No. SL-AG-69

Service Letter No. SL-AG-69
February 24, 1975

WING LEADING EDGE RIB RIVETS

EFFECTIVITY: MODEL S-2R, SERIAL NO'S 1416R THRU 2155R
5000R THRU 5010R.

Figure 1.

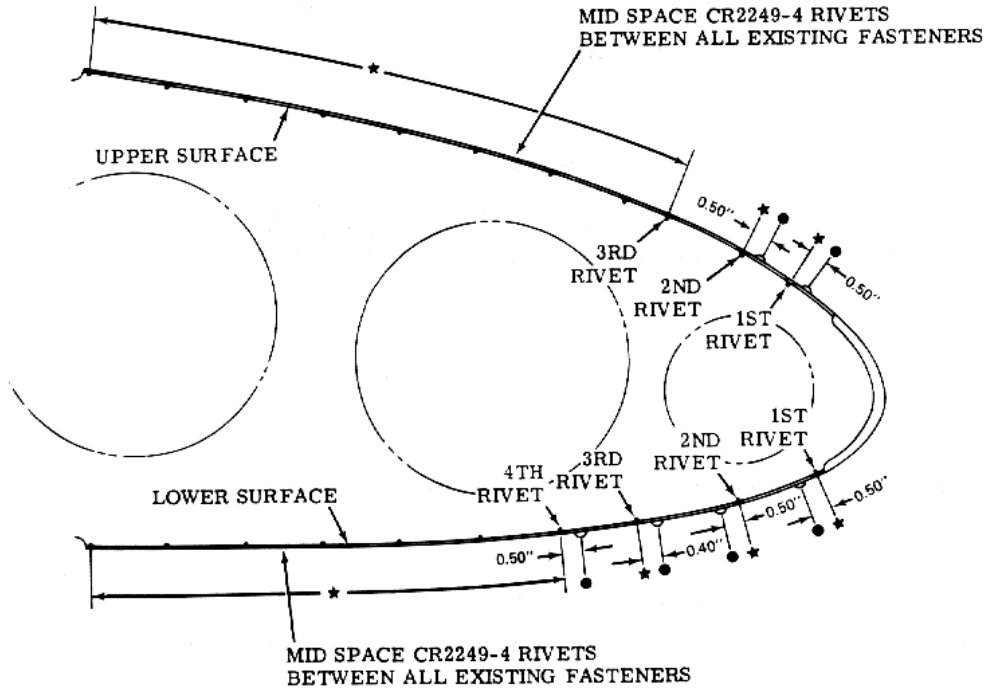
- a. Remove and replace any loose existing rivets on wing leading edge ribs with CR2248-4 blind rivets (see Figure 1.).

- b. Using a No. 27 drill, drill and install CR2249-4 blind rivets, on upper and lower surface of wing leading edge ribs, mid-spaced between existing rivets (see Figure 1.).
- c. Using a No. 27 drill, drill and install additional CR2249-4 blind rivets on nose of wing leading edge ribs in area shown in Figure 1.
